REBUTTAL REPORT: PART 1

**REVIEW OF EVIDENCE REPORTS SUBMITTED BY SOUTHERN NEVADA WATER AUTHORITY IN SUPPORT
OF WATER RIGHTS APPLICATIONS FOR SPRING, CAVE, DRY LAKE, AND DELAMER VALLEYS**

Presented to the Office of the Nevada State Engineer

August 25, 2011

Figure 1: Snapshot of Figure E-1 (Burns and Drici, 2011) showing SNWA's perceived interbasin flow to or from the WRFS.

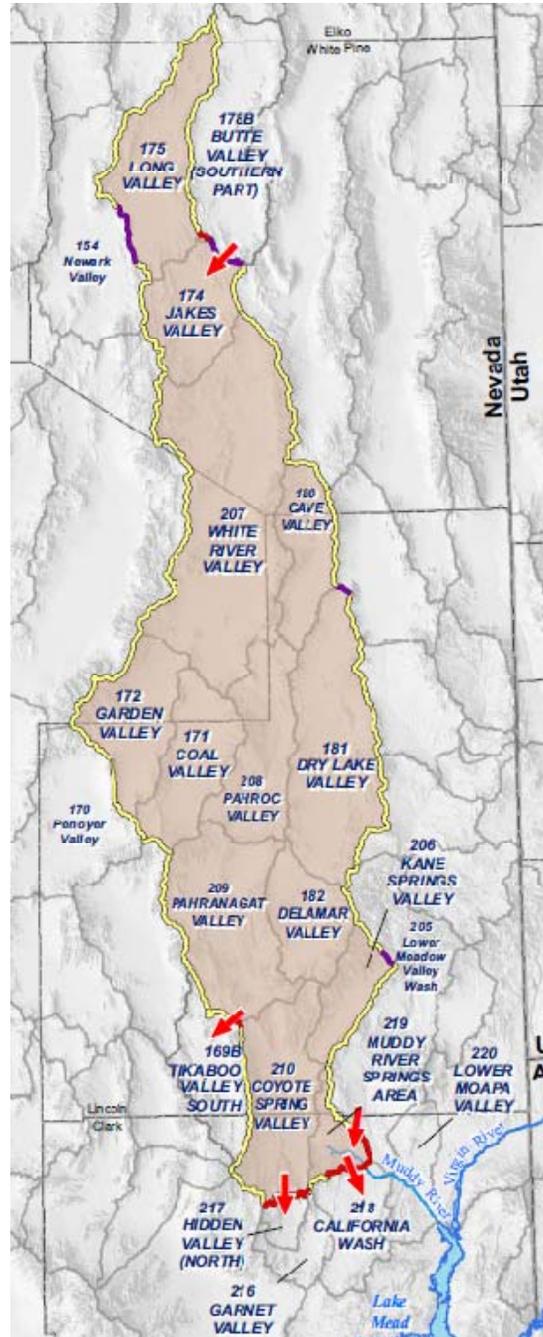
The remainder of this section reviews the components of the water balance calculation: GWET and interbasin flow. Because of the overlap, I consider the WRFS and Spring Valley jointly. The WRFS includes a north-south trend of basins commencing with Long and Steptoe Valleys in the north and culminating with Lower Moapa Valley and California Wash in the south. Figure 1 shows SNWA’s perception of the WRFS, including the interbasin flow which will be considered below. Importantly, it does not include Steptoe Valley because they reject the concept of interbasin flow from that valley to the WRFS.

Many of SNWA's arguments for and against interbasin flow depend on an assessment of the geology of these boundaries, mostly based on geologic arguments made by Rowley et al (2011). A major problem with their analysis is that **they make hydrologic conclusions regarding faults without any hydrologic data**. They conclude based on their interpretation of the geology, with a heavy emphasis on faulting, whether flow is likely, permissible, or impossible.

Figure 3: Snapshot from Rowley et al (2011), Plate 1, showing their geology in the Egan Range and other areas near Ely.

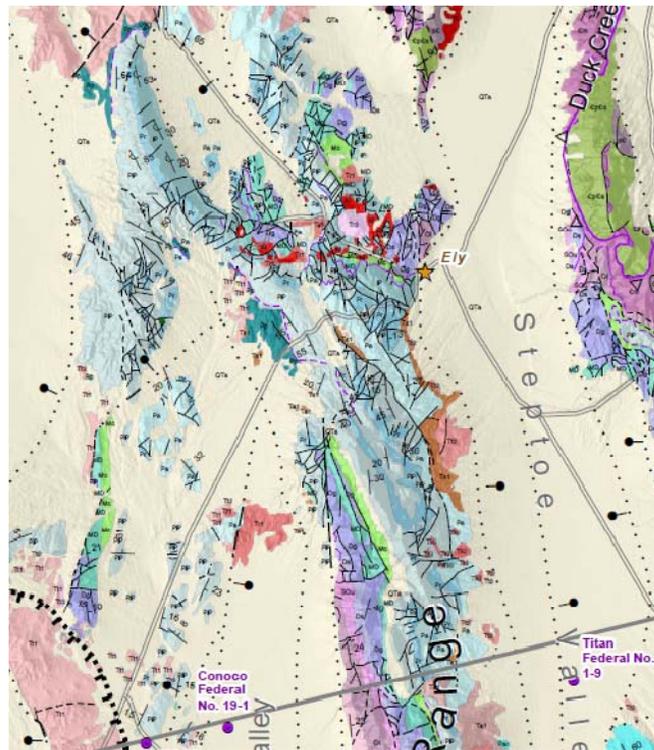
SNWA argues there is no flow from Steptoe Valley to any adjacent valley, based on strident geologic arguments (Rowley et al, 2011, ps. 6-6, 6-7, 6-11, and 6-12). The arguments are based mostly on the presence of faults or high elevations over the pass, and simply do not have any hydrologic data to support them. For example, Figure 3 shows significant Riepe Spring and Ely Limestone in the Egan Range south of Ely and significant faults, but they present no hydrologic evidence that no flow occurs.

Figure 4: Snapshot from DEIS Figure 3.2-5 (BLM, 2011) showing drawdown in Spring, Lake, Steptoe, and Cave Valleys.

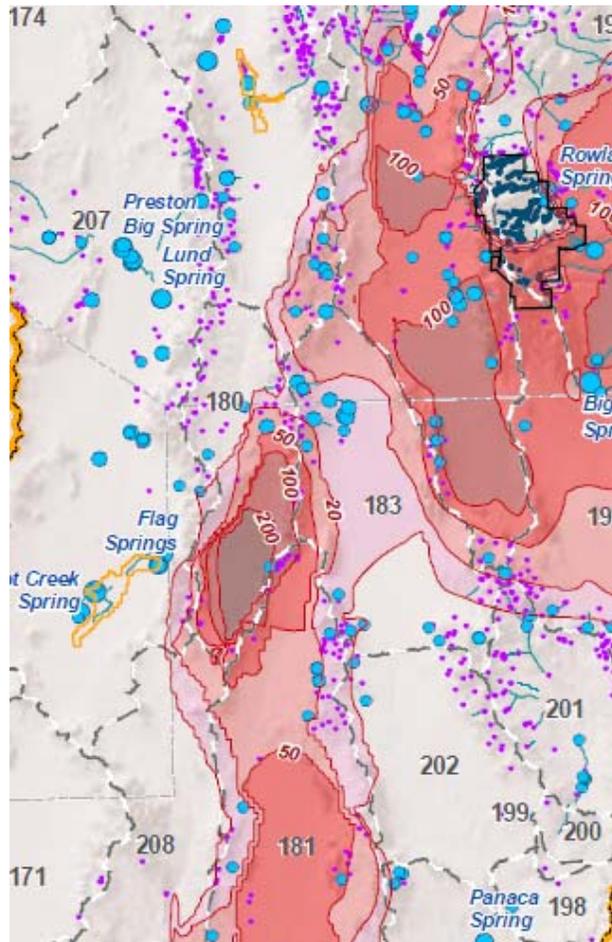
Finally, SNWA’s groundwater model as used in BLM (2011) demonstrates that flow can occur between Steptoe and Spring Valley. Figure 3.2-5 (BLM, 2011) shows that up to 50 feet of drawdown occur in the north end of Lake and the southeast portion of Steptoe Valley (Figure 4). This can only occur if and only if the geology coded into the model allows this flow. The baseline data reports for the DEIS model (BLM, 2011) were SNWA (2008 a and b). SNWA (2008b) does not specifically address this interbasin flow. The conceptual model report (SNWA, 2009a) includes the flow only as part of an uncertainty analysis in their flow system water balance model. It seems that SNWA’s reports reject the potential for flow between Steptoe and surrounding valleys, but the model authors found it difficult to code the faults as

substantial enough barriers to truly prevent the flow. BARCAS estimated that 20,000 af/y flows to Lake and 4000 af/y to Spring Valley from Steptoe Valley (Figure 2).

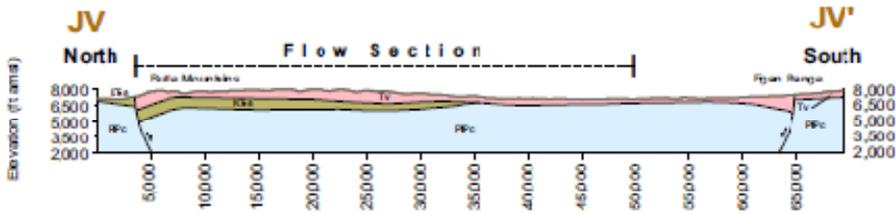
SNWA estimates that 6700 af/y flows from southern Butte to Jakes Valley (Figure 6), whereas BARCAS estimated 16,000 af/y. Interestingly, their map (Burns and Drici, 2011, Figure E-2) shows flow through this section only as “permissible” and also shows several normal faults that are perpendicular to the proposed flow path; they do not explain why these faults do not prevent the flow when in some many other points throughout the study domain normal faults do prevent flow. However, they may have underestimated the interbasin flow in the WRFS by setting the thickness too low. They used a mean K of 6.16 ft/d and two cross-sections, 30,000 by 500 feet and 15,000 by 1500 feet; the thicker section is on the right (Figure 6). Burns and Drici (2011) do not justify their assumed thickness. Their figure shows thickness of up to 4500 feet, which could be thicker yet if the carbonate rock continues lower than the chosen section. Even if their chosen conductivity is too high (a mean K may not apply to bulk carbonate rock), the additional thickness applied to the section suggests the cross-sectional flow could be much higher - much closer to the BARCAS value. This is another example of how SNWA’s Darcian flow estimate’s failure to account for surrounding basin water budgets leads it to significantly underestimate inflow to the WRFS.

Figure 7: Snapshot from Figure E-4 (Burns and Drici, 2011) showing Muddy River springs and the fault that controls the springs. The map also shows the cross-section used by SNWA for estimating flow from MRSA to California Wash.

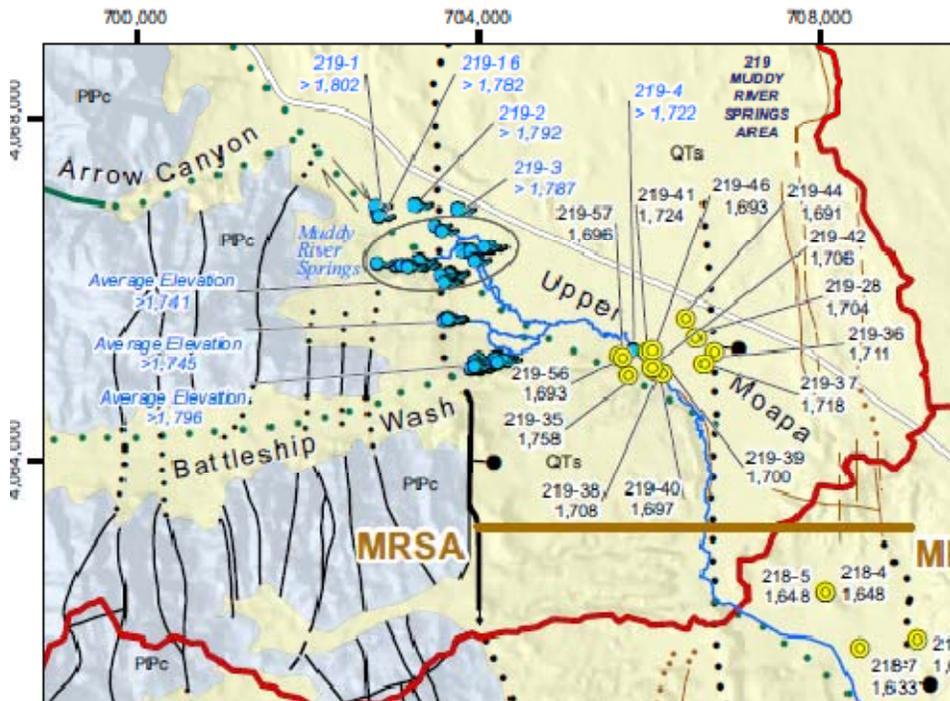
Interbasin outflow estimates from the WRFS are just as fraught with uncertainty. For this analysis, SNWA cut off the south end of the WRFS at the discharge from the Muddy River Springs Area to California Wash and from Coyote Spring Valley to Hidden Valley. The MRSA discharge consists of discharge from the springs, which SNWA estimates to be 33,700 af/y, and groundwater flow to California Wash estimated to be 9900 af/y. The problem with the groundwater flow estimate is that there would be no available flow from the area of the springs because the springs are controlled by faulting (Rowley et al, 2011) (Figure 7) which would cause most to discharge.

SNWA estimates flow across the cross-section in Figure 7 to be 9900 af/y, but as noted based on the faults controlling the springs, there is likely little flow from upstream in the WRFS to this section. SNWA estimates that 8000 af/y enters the MRSA from the Lower Meadow Valley Wash; they base their estimate on other studies. Based on the location to the east side of the MRSA and the faults, it is not likely that much of this water discharges from the springs either. For the purpose of the WRFS, it would be appropriate to assume that discharge to California Wash from the MRSA equals the flow from the Lower Meadow Valley Wash, and not include it in further water balance calculations.

Figure 8: Snapshot from Figure E-3 (Burns and Drici, 2011) showing the perceived flow path from Coyote Spring to Hidden Valley.

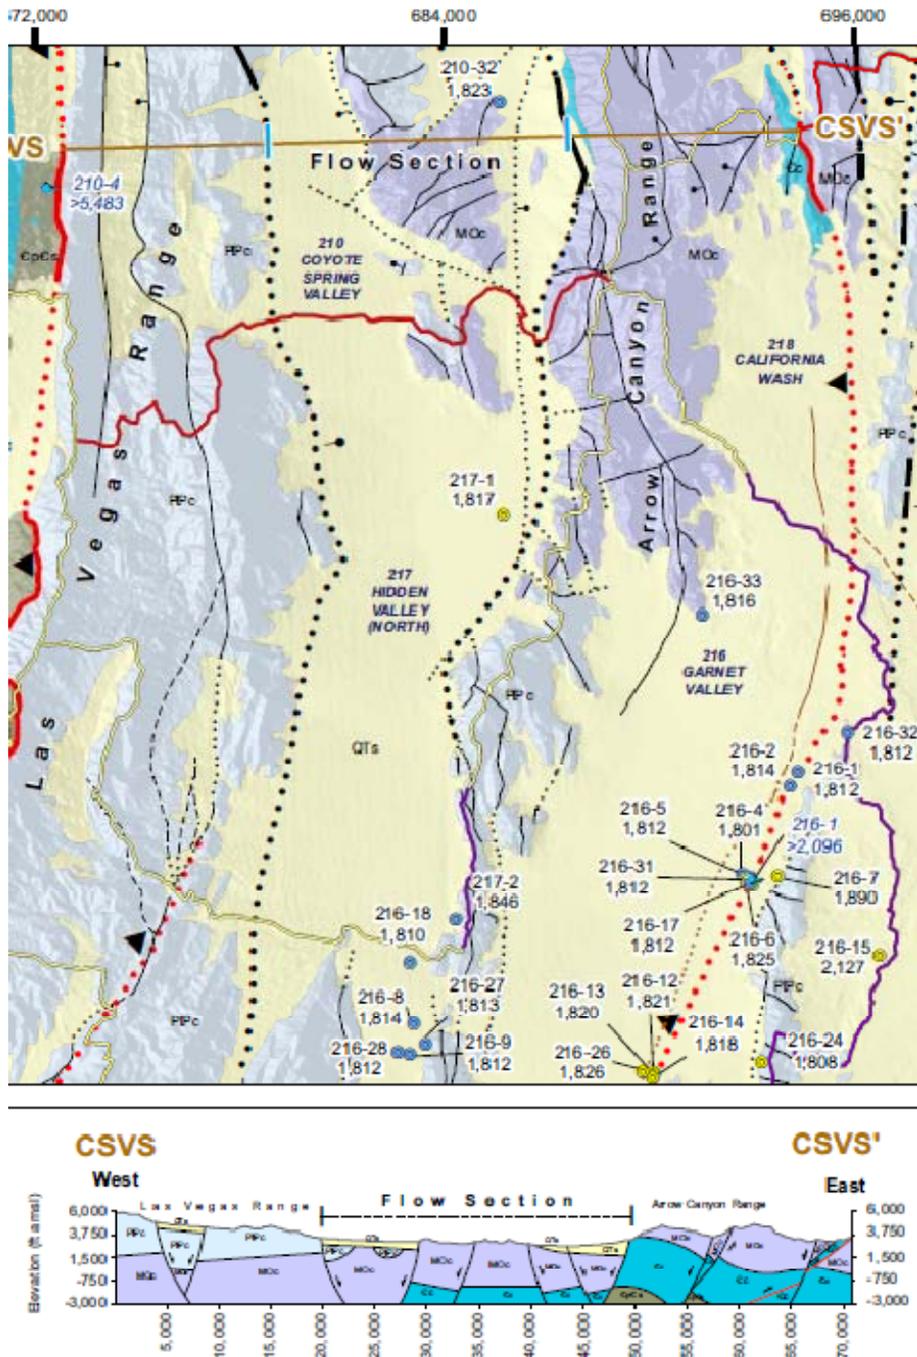
The gradient from Coyote Springs to Hidden Valley is essentially flat), with a six foot drop from well 210-32 to 217-1, over about eight miles (Figure 8). SNWA estimated flow between these valleys using Darcy’s law with a geometric mean transmissivity of approximately 213,000 ft²/d and a 30,000-foot width and a gradient determined between wells CSVM-2 (210-32) and GV-1 (216-18)(Figure 8). The extremely low gradient and high transmissivity are both potential errors in this calculation. Over this long distance, it is a large assumption that the flow paths are connected so that the gradient accurately depicts the real situation. Intermediate water levels could be significantly higher so that a smaller gradient or even a divide is reality; a few feet could make the difference. SNWA uses an average transmissivity from the tabulated pump tests (Table E-1, Burns and Drici, 2011). SNWA claims these are representative because they only used long-term tests. Several of the wells on that table are known high producers. SNWA likely represents wells in significant fracture zones which would have a high conductivity. It should be noted that the section (Figure 8) spans a carbonate outcrop several miles into Coyote Spring Valley, again near the high producing wells. There is no evidence this section is representative for flow between the valleys.

Although it is impossible to rule out any flow, based on the extremely low gradient and fracture-based transmissivity of fracture systems, the flow would be much closer to zero. The deuterium measurements provided do not indicate a flow but merely indicate the groundwater in the carbonate rock in Coyote Spring and Garnet Valley could have a similar source.

Figure 9: Snapshot of portion of Burns and Draci (2011) Figure B-2, Locations and Data Sources for Precipitation Stations Located in Area of Interest.

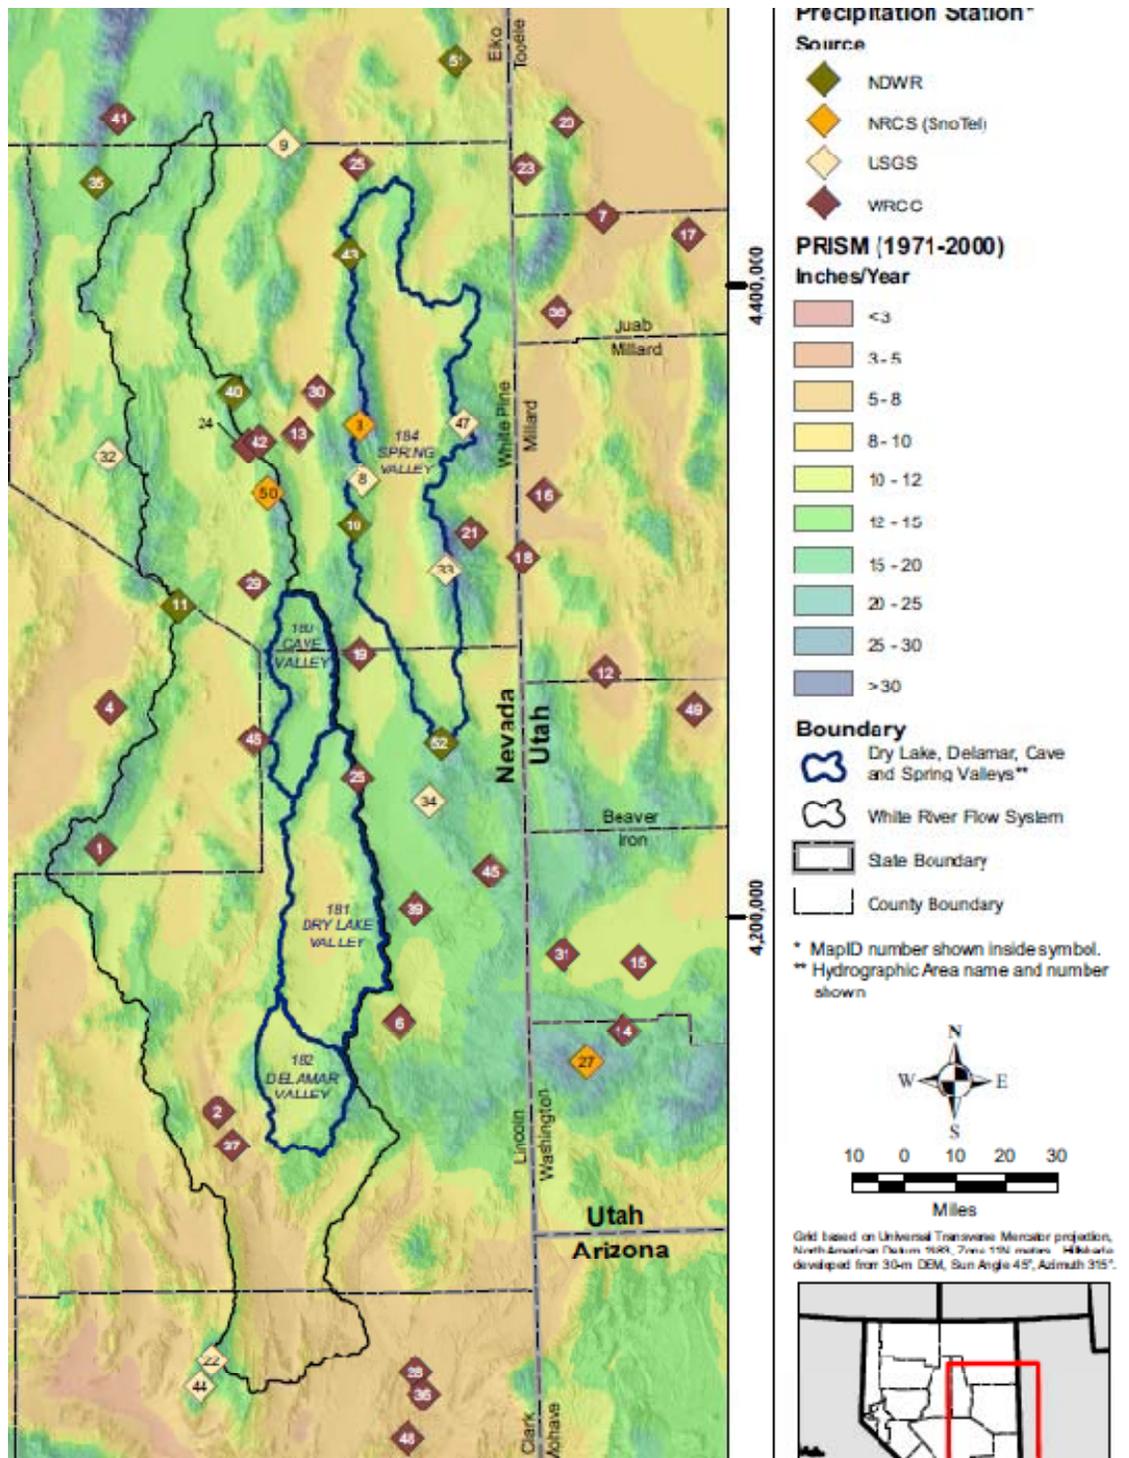
The distribution of annual precipitation determined with PRISM and the precipitation stations used by SNWA to compare with PRISM estimates is shown on Figure 9. The major problem with this distribution is the band of high precipitation that is evident, mostly in lower elevations, from southern Cave Valley through Lake and Patterson Valley to southern Hamlin Valley. This band of higher precipitation in the valleys ranges from 12 to 15 in/y. Southern Cave Valley is in this band even though it is 1000 feet or more lower than the valley in the northern part. The low divide between Patterson and Lake Valley is less than 6000 feet, but precipitation is in the 12 to 15 in/y range (Figure 9). PRISM has a broad extent of Spring Valley, near or slightly lower than 6000 feet, with precipitation ranging from 8 to 10 in/y.

There are few, if any stations within Cave, Dry Lake or Delamar Valleys, and just a few around the rim of Spring Valley (Figure 9).

Figure 10: Snapshot of the Cave Valley portion of Plate 6, Rowley et al (2011). Section R-R' crosses the middle of Cave Valley and the section above it, with labels outside of the snapshot, is U-U'

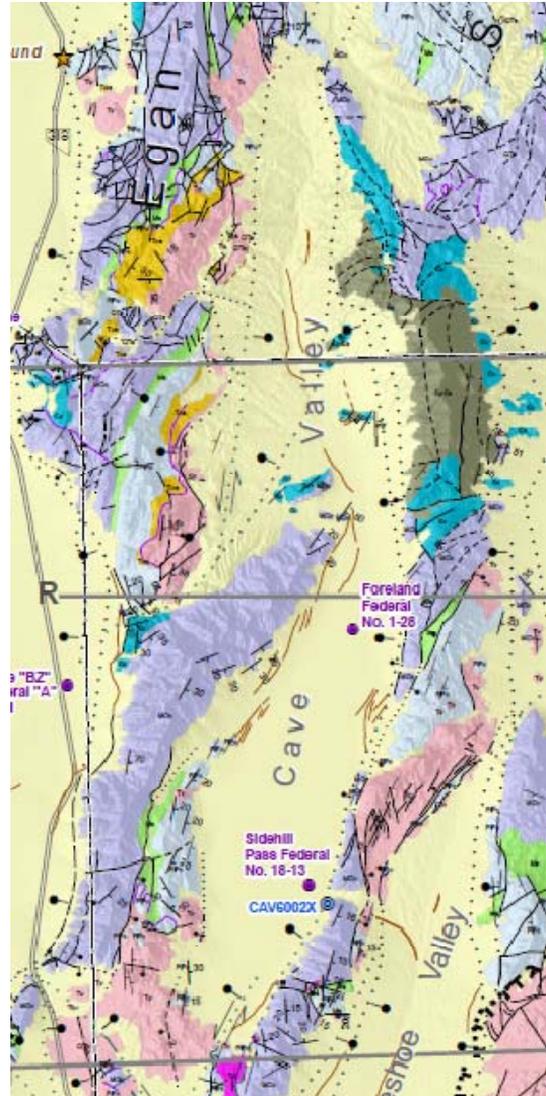
The geology as presented by Rowley et al (2011) does not support the argument and even provides substantive evidence opposing SNWA's view. Figure 10 shows Rowley et al's hydrogeology map for Cave Valley; the carbonate block extending northeast across the valley from the Egan Range is obvious on the map. Cross-section R-R' (Figure 11) shows a section which would support flow along the east side of Cave Valley, but unless the carbonate block is fractured, it would not. Section U-U' (Figure 12) shows a thin fill section underlain by volcanic, carbonate, and clastic rocks. A section through the tip of the carbonate block showing their perception of the section between the block and the Schell Creek Range would have been useful.

The carbonate block extends about two-thirds of the distance across Cave Valley, so groundwater generated on the western two-thirds or that flows from the Schell Creek Range into the western two-thirds would be blocked by the carbonate block and diverted toward Shingle Pass. The block itself contains Mississippian chert shale (SNWA, 2008b), generally a very impervious layer separating carbonate aquifers. SNWA (2008b) generally describes the block as separating the valley into two subbasins – hardly a description they would make if most of the water in northern Cave Valley would flow south.

shown on Figure 10 and on Myers (2011a) Figure 2 allow groundwater to cross Rowley et al.'s fracture zone flowpath and be diverted southwest toward Shingle Pass (Myers, 2011a; Welch et al, 2008).

Figure 15: Snapshot of Dry Lake Valley and surrounding area isotope values from Thomas and Mihevc (2011), Plate 2. Blue, red, and black circles are cold and warm springs, and representative wells, respectively.

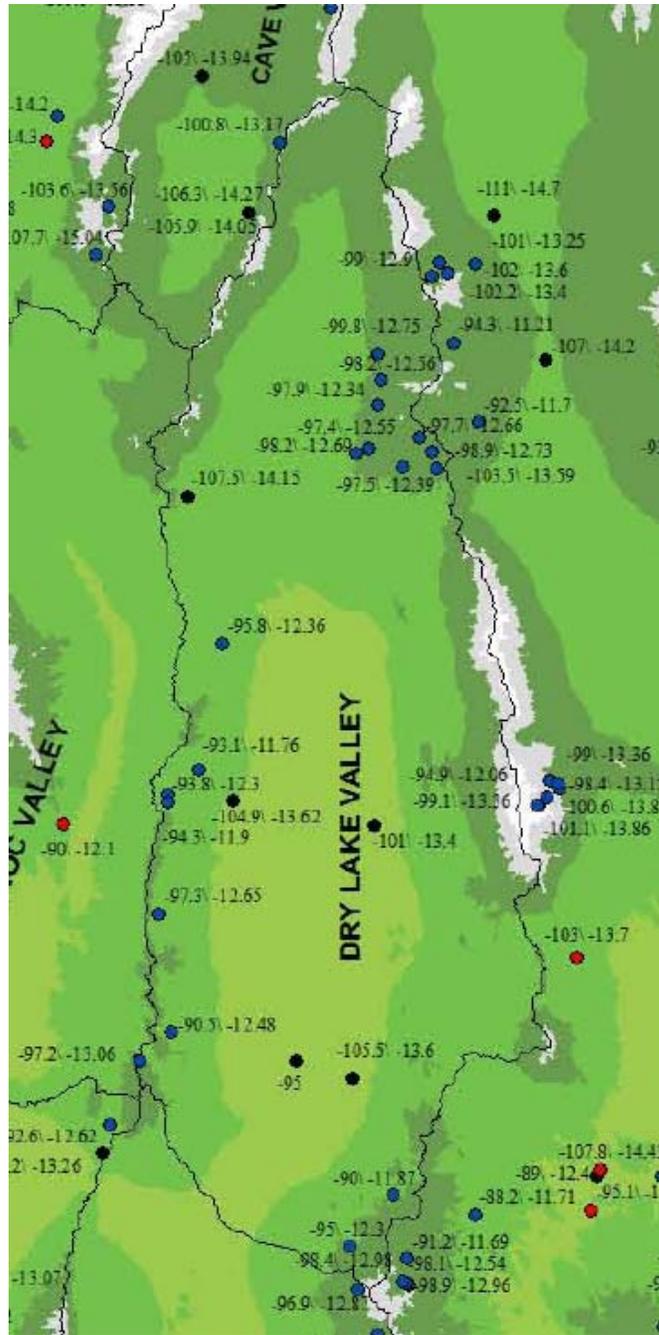
The isotope data in Dry Lake Valley (Figure 15) support the idea that the valley actually has very little recharge. The authors suggest that the well in the northwest portion of the valley with δD equal to -107.5 permil has water from Pahroc or Cave Valley to the west (Thomas and Mihevc, 2011, p. 22). This could be correct, and if so, it suggests there is little mixing of this interbasin flow with local recharge; all springs representing local recharge have δD greater than -100 permil. The authors acknowledge that the two wells in the central portion of the valley having δD equal to -104.9 and -101 permil do not reflect local recharge (*id.*). Of the two wells in the far south of the valley, only the one with δD equal to -

95 permil could reflect local recharge, although its value is actually less negative than most of the recharge observations. The only springs with less negative values are in the far south of the valley which suggests the water in that well reflects recharge in that portion of the valley.

Five of the six wells that represent native groundwater in Dry Lake Valley apparently reflect groundwater from further up the flow system – interbasin flow. Little of the groundwater in Dry Lake Valley actually results from recharge within the valley. This supports the rebuttal arguments elsewhere and the direct evidence in Myers (2011a) suggesting that recharge in Dry Lake Valley is much less than determined by Burns and Drici (2011). If the groundwater within the Valley does not reflect recharge within the valley, the only conclusion is that the groundwater is from interbasin flow.
